HOT CHANNEL FACTOR
NORMALIZED OPERATING ENVELOPE

ATTACHMENT 1

- A. Evaluation of the potential impact of using fuel rod models presented in draft NUREG-0630 on the Loss of Coolant Accident (LOCA) analysis for Turkey Point units 3 & 4 with 25% SGTP and 5% red.TDF.

Figure 3.2-3b

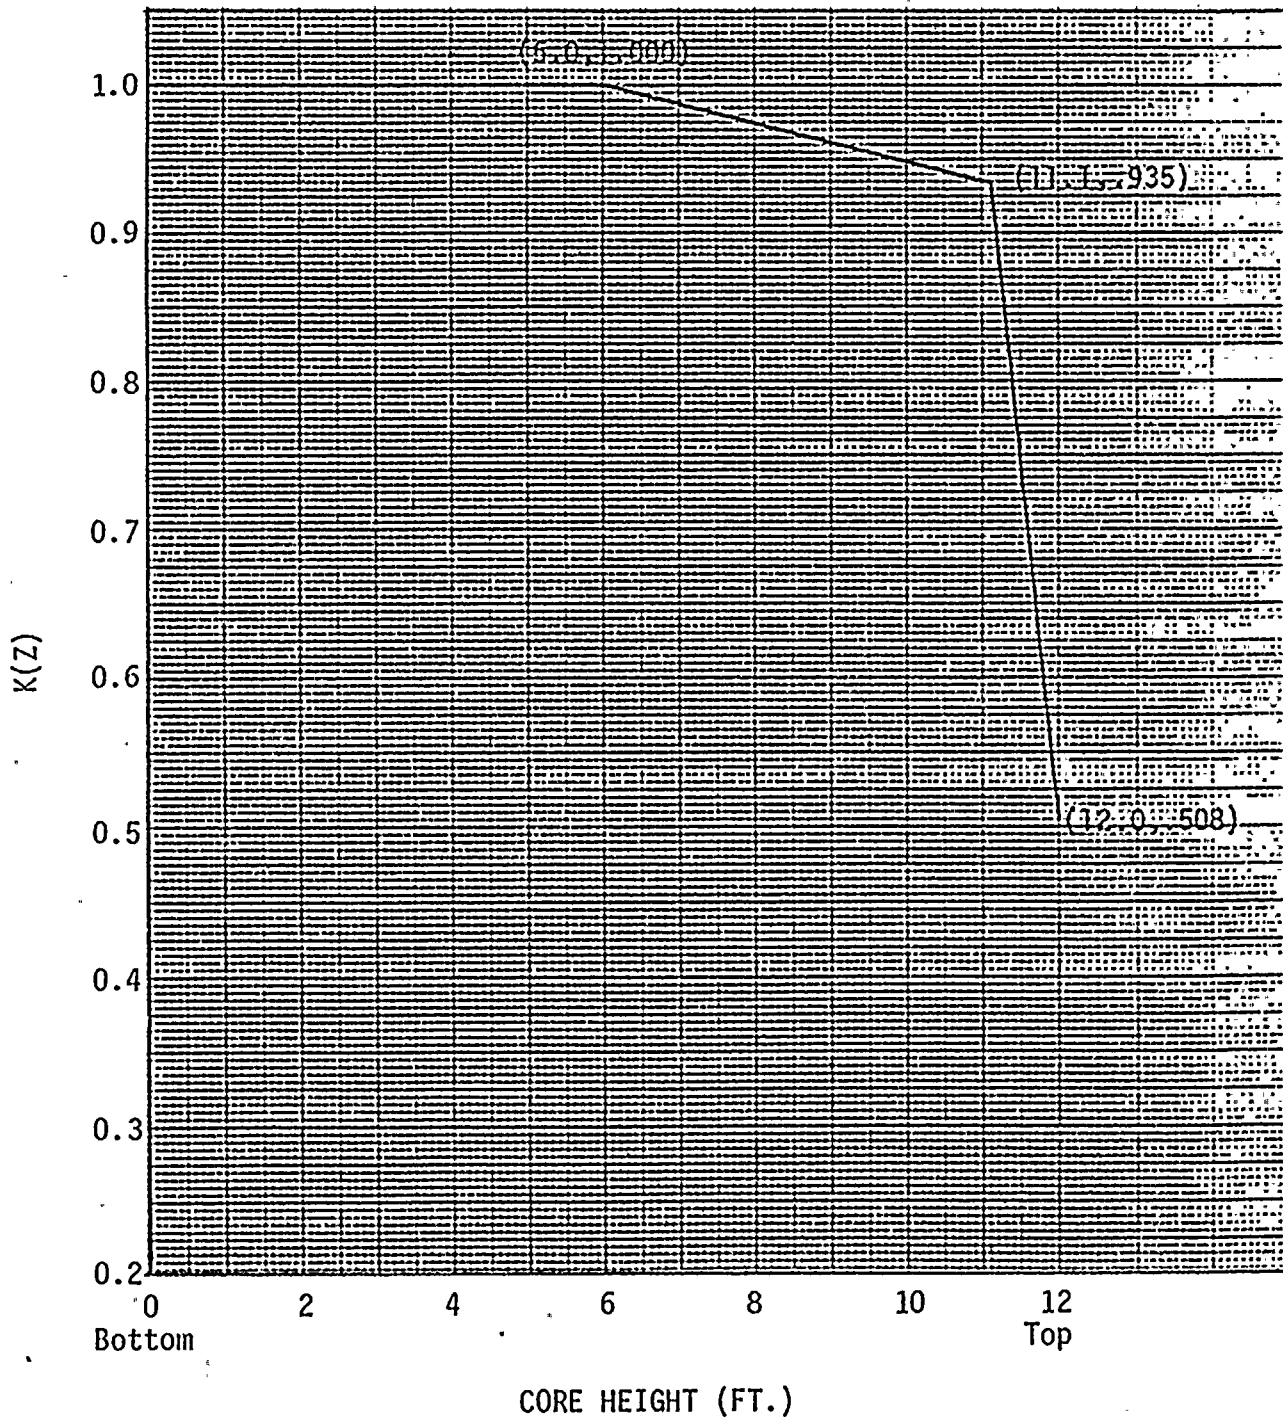
- (1) With steam generator tube plugging >22% and ≤25%, the hot channel factors (defined in the basis) must meet the following limits at all times except during low power physics tests:

$$F_q(Z) \leq (1.97/P) \times K(Z), \text{ for } P > .5$$

$$F_q(Z) \leq (3.94) \times K(Z), \text{ for } P \leq .5$$

$$F_{\Delta H}^N \leq 1.55 [1.0 + 0.2 (1-P)]$$

Where P is the fraction of rated power at which the core is operating; K(Z) is the function given in Figure 3.2-3b; Z is the core height location of F_q .

If F_q , as predicted by approved physics calculations, exceeds 1.97, the power will be limited to the rated power multiplied by the ratio of 1.97 divided by the predicted F_q , or augmented surveillance of hot channel factors shall be implemented.
